NATIONAL TRANSPORT RESEARCH CENTRE

REPORT  
ON  
LAHORE - ISLAMABAD MOTORWAY

NTRC-201

June, 1997

PLATE-7 : FLYOVER BRIDGE WITHOUT APPROACH ROAD

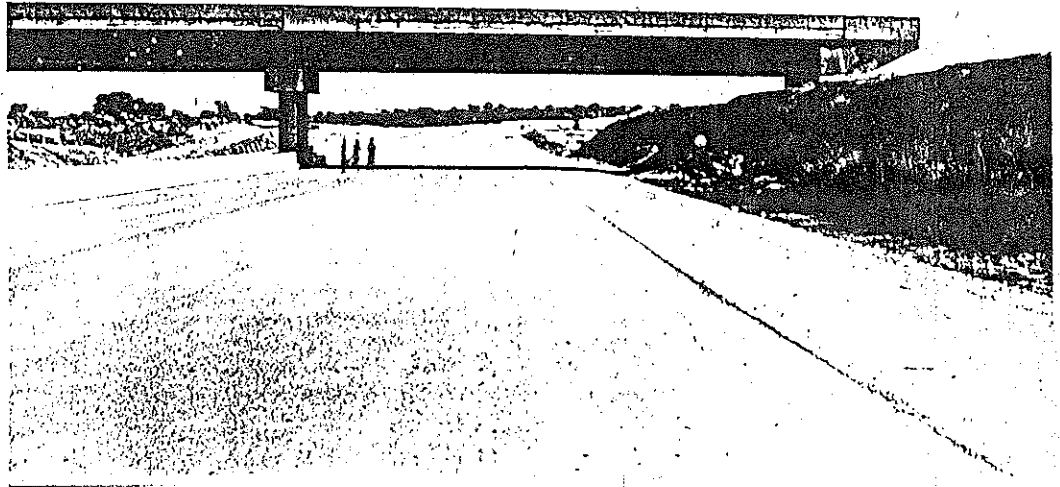
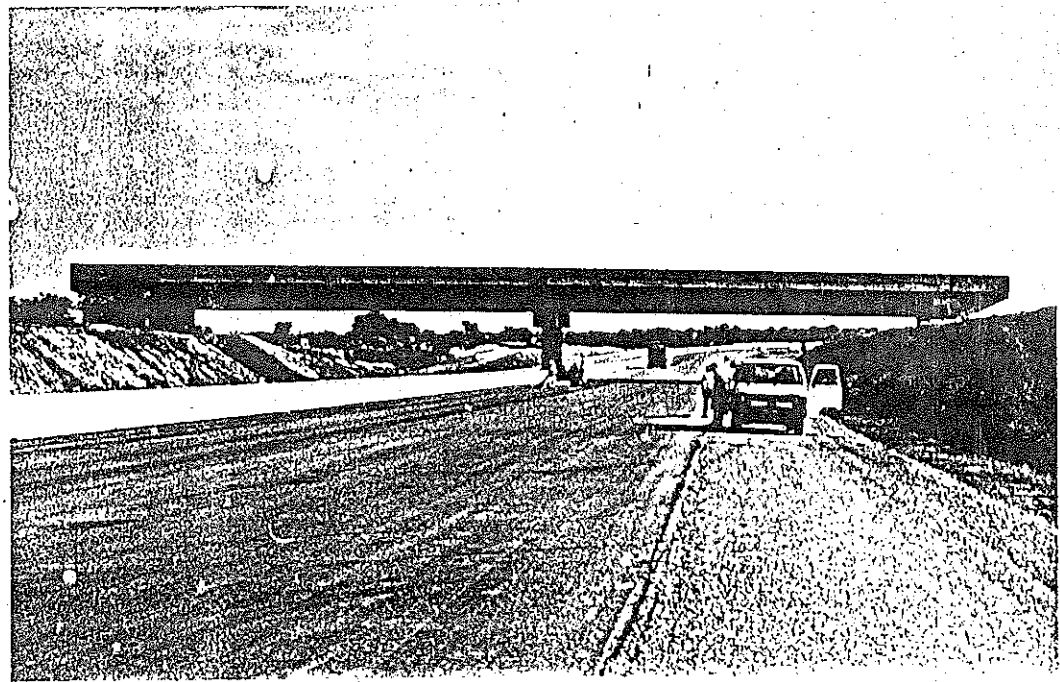
4.2 Fly-Over Bridges: It was also observed that at certain locations, the fly-over bridges on the motorway were without approach roads. No construction activities were

seen on the approaches which means that opening of the motorway to traffic without providing grade separated crossing facilities would pose serious safety hazards both for the Motorway traffic and the traffic crossing the Motorway. Plates-7 and 8 show the problem.

PLATE-9 : BASE COURSE SURFACE, WEARING COURSE STILL TO BE LAID

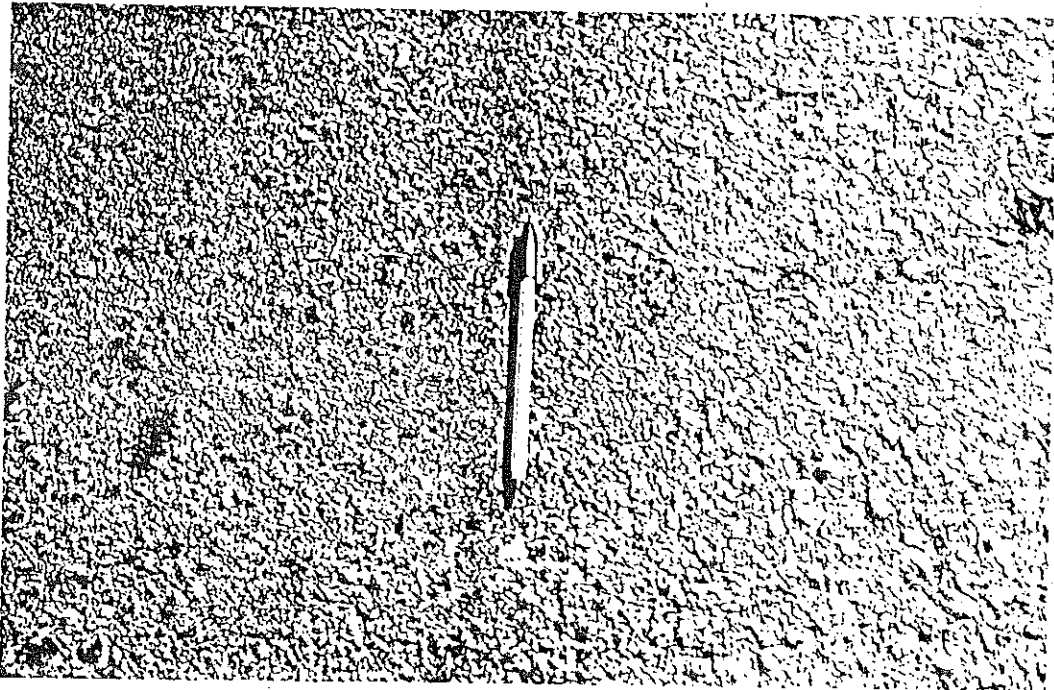
4.3 Binder Course Sections: At some locations only the binder course was laid on pavement and wearing course is still to be laid. This leads to confusion to the vehicle user about the riding quality at such sections. Plates-9 & 10 show such locations.

PLATE-11 : LANDSLIDES - BENCHING/STEPPING BEING PROVIDING

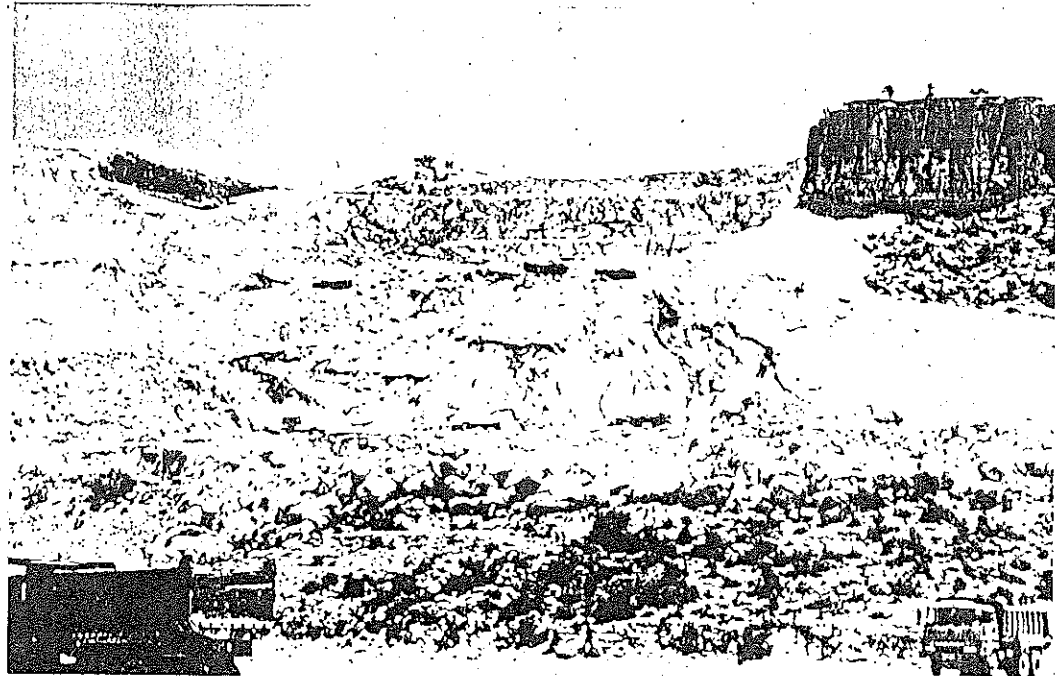
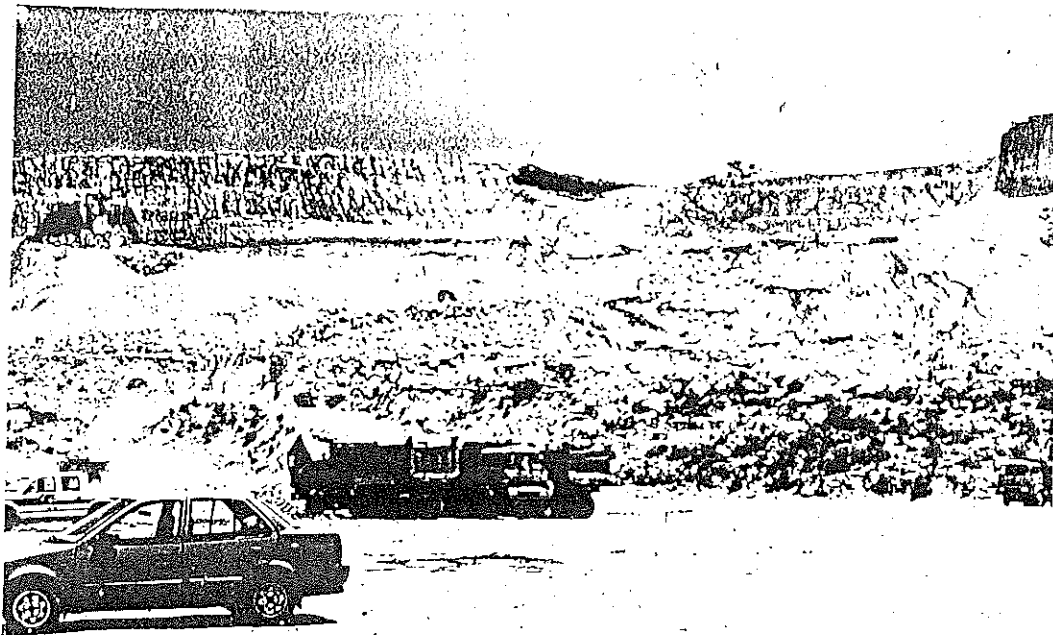
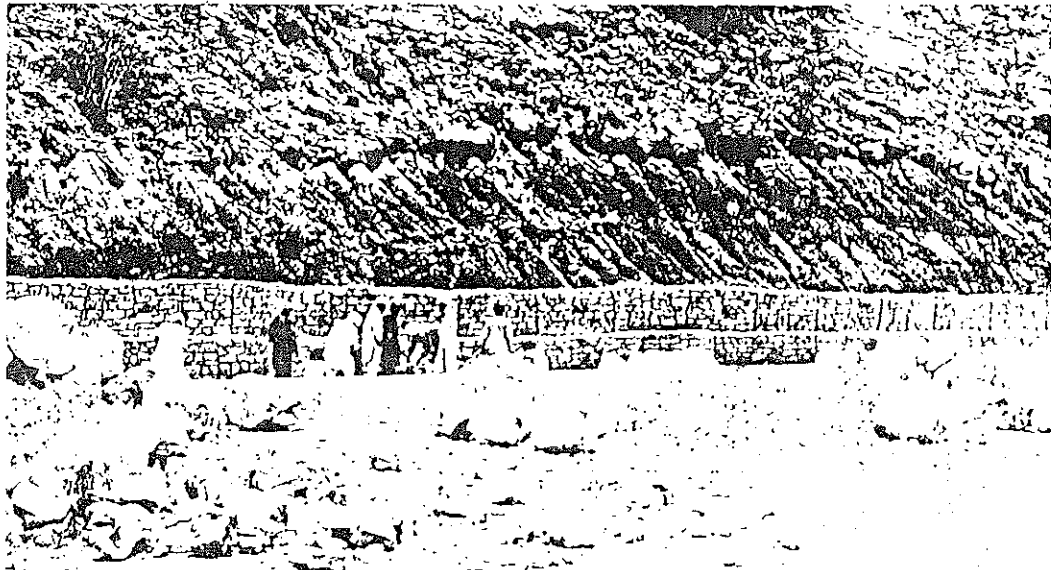
4.4 Landslide Problem in the Salt Range Area: The Motorway is passing through the salt range area near Kaler Kahar in about one kilometer length. When the hill was blasted to make the roadway, the land slide phenomena started. According to the consultants, they have properly designed the slopes keeping in view the geological properties of the rock and after removing the over burden material, they will bring the hill side to the proper slope and shall also provide stepping/benching. According to the Assistant Resident Engineer of the consultant M/s SMEC, gabions would also be placed to prevent the land sliding. According to the consultants, it is only a matter of time and when enough overburden material is removed from the top hill, the slopes will become stable. Plates-11 to 14 exhibit the landslide problem and the construction activities going on the site.

PLATE-16: LONGITUDINAL CRACK IN THE C-6 BRIDGE'S PIER  
DUE TO UN-EVEN EARTH FILLING

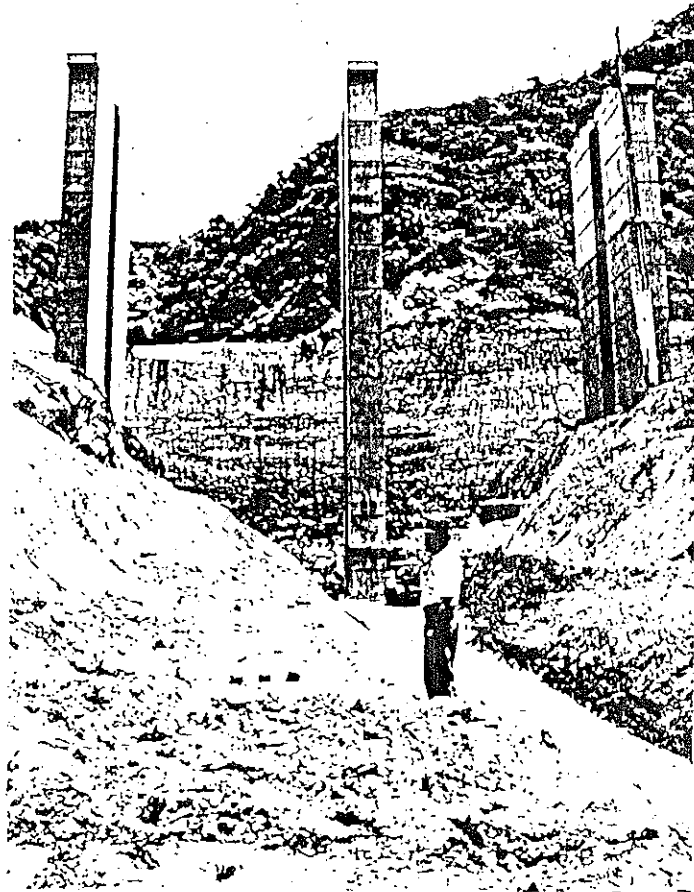
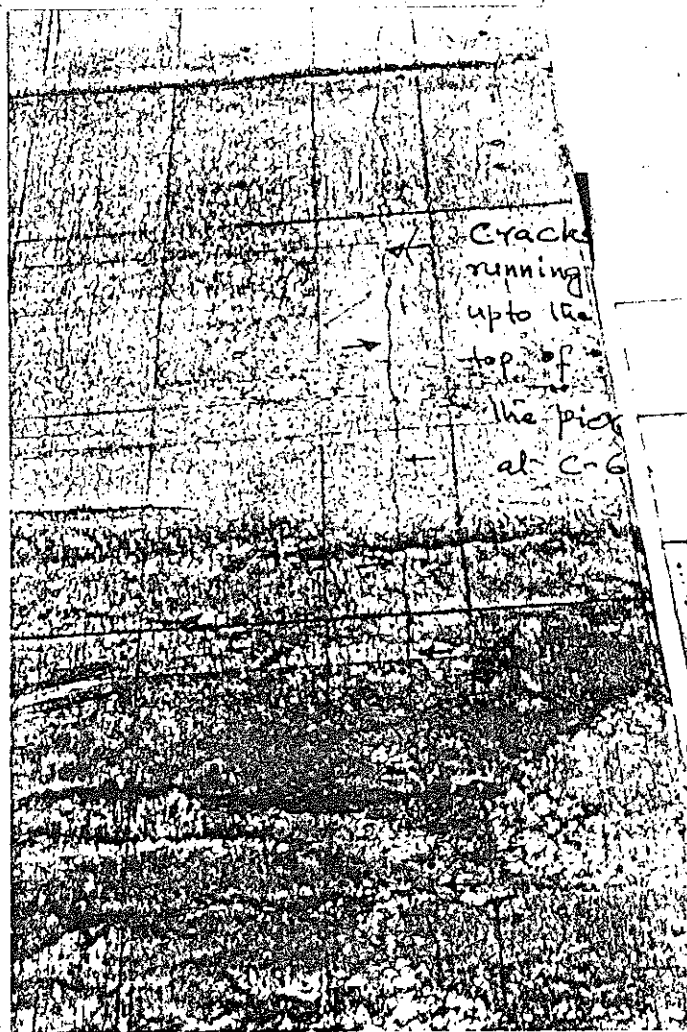
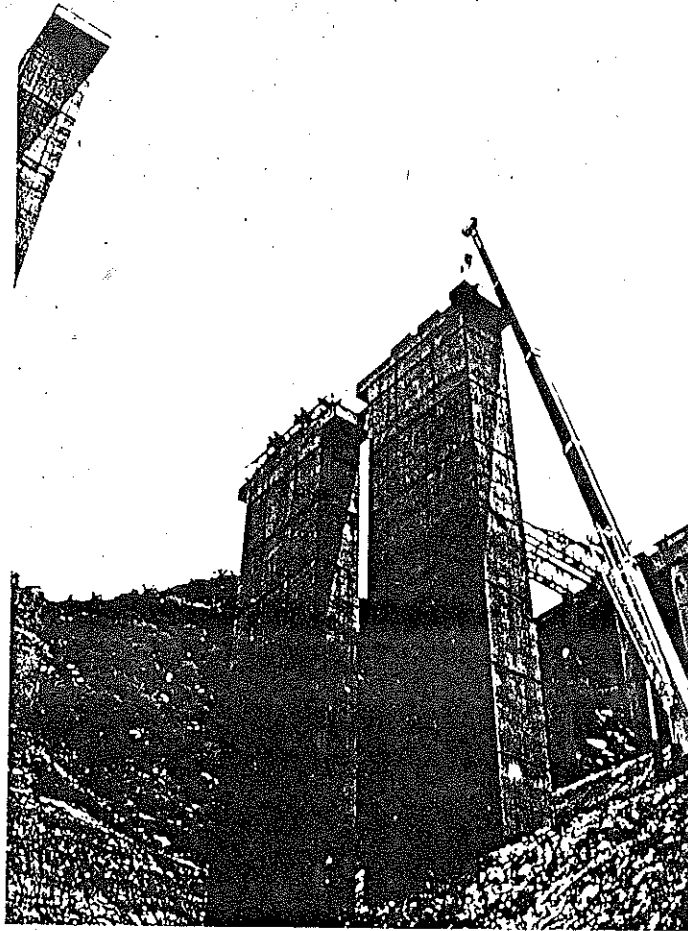
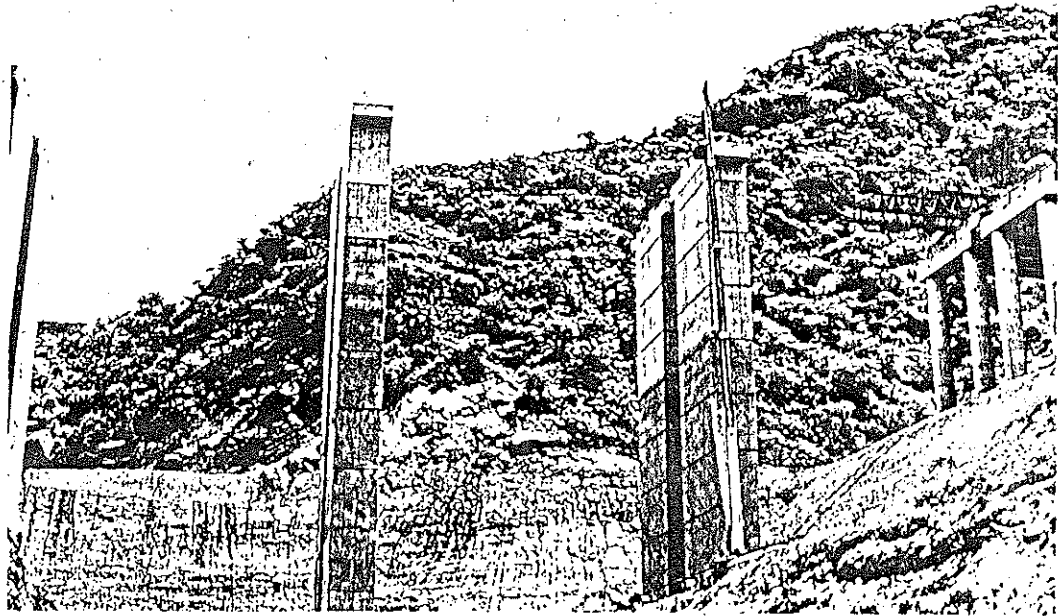
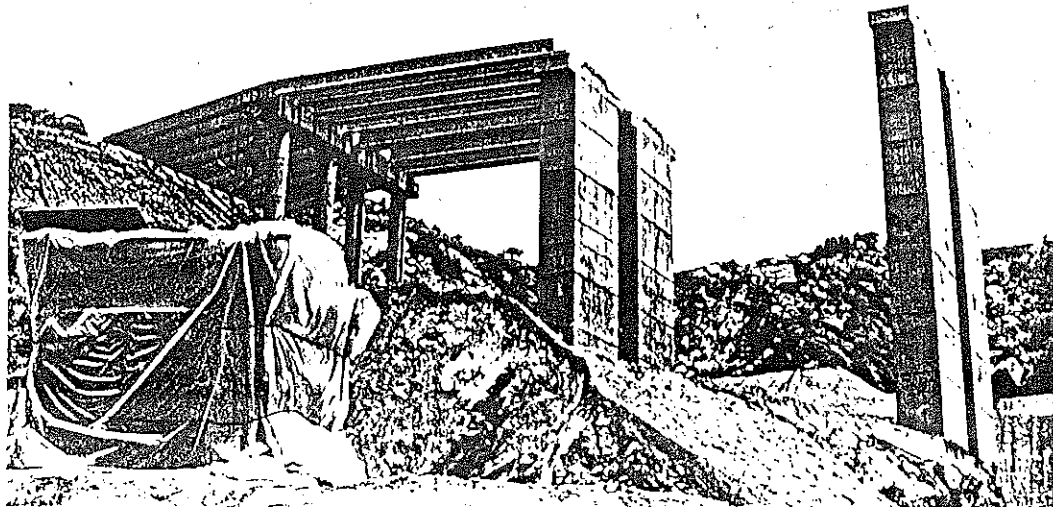
4.5 Observations at C-6 Bridge : The main problem at C-6 bridge was tilting and development of cracks around the height of the bridge piers. The bridge piers are about 270 feet high. The tilting and cracking in the piers developed due to un-balanced earth filling around the piers. The contractor filled earth around the piers so that gantry cranes could be put near the bridge piers for hoisting the bridge girders. In fact, the contractor's technique of hoisting bridge girders using gantry cranes was not in line with the procedure laid down in the contract document. In fact the contractor should

have used the launching platform to hoist the girders. Now the filling around the piers have been removed and the hollow section of the pier is injected with cement concrete. After removal of the earth filling around the piers and injection of cement concrete, the cracks have been rectified and the bridge piers are now in correct position. The contractor has also mobilized proper launching platforms for hoisting the girders. Plates-15 to 19 show the problems encountered and the present position after remedial measures.

PLATE-20 : PIER CAP JACKED UP AND STEEL COLUMN PLACED UNDER THE CAP

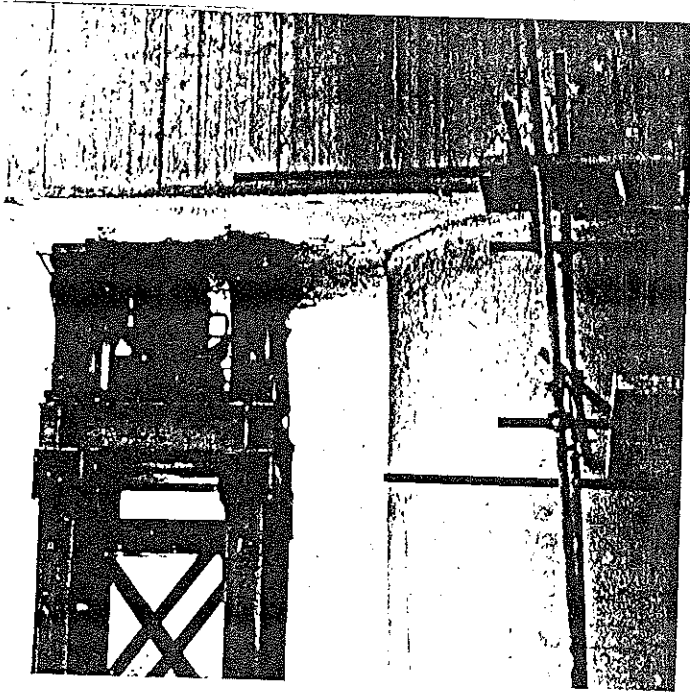
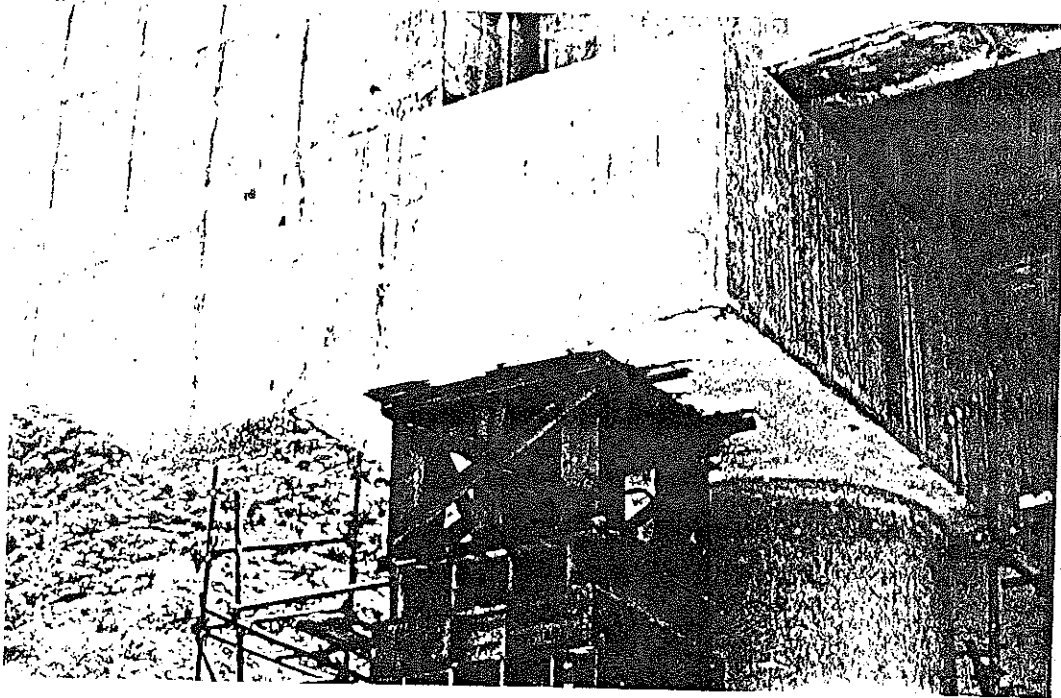
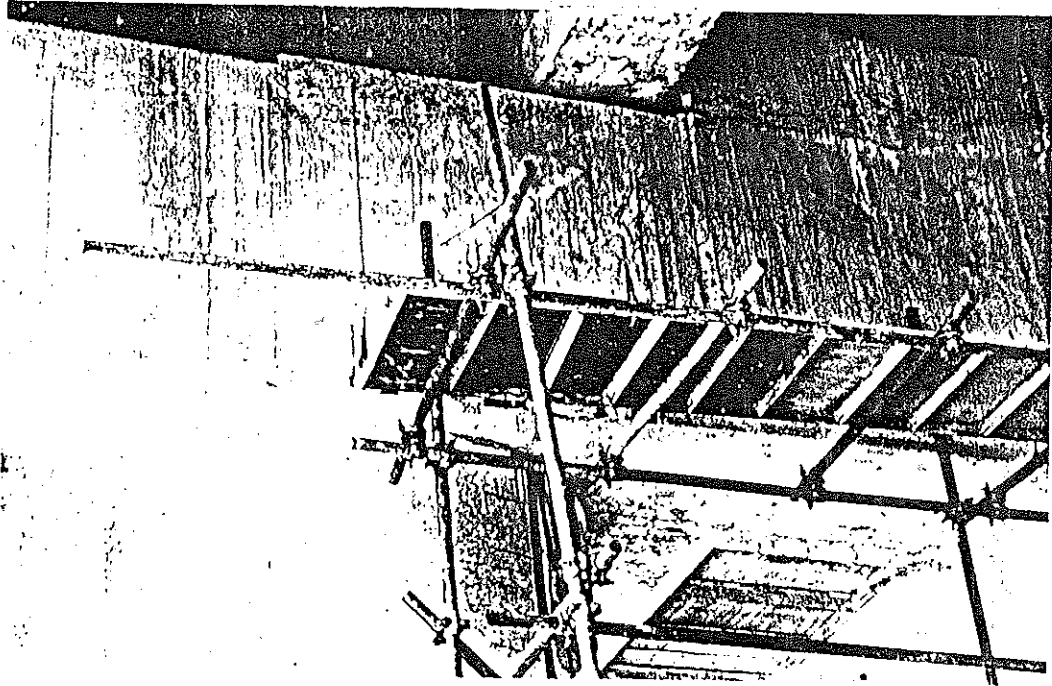
**4.6 Observations at C-5 Bridge:** The problem at C-5 bridge appeared in the form of cracks in the pier cap due to settling down of one pier of the C-5 bridge. This problem has been overcome by placing two RCC foundations adjacent to the problematic pier. On top of the RCC foundations, heavy steel columns have been put and after jacking up the pier cap to its original position using high pressure pneumatic jacks, steel plates have been pushed under the pier cap to fill the gap. After bringing the pier cap into the original position, the jacks have been released. The cracks in the pier cap have been properly drilled out & filled up with proper epoxy material. Plates-20 to 21 show the treatment made to C-5 bridge.
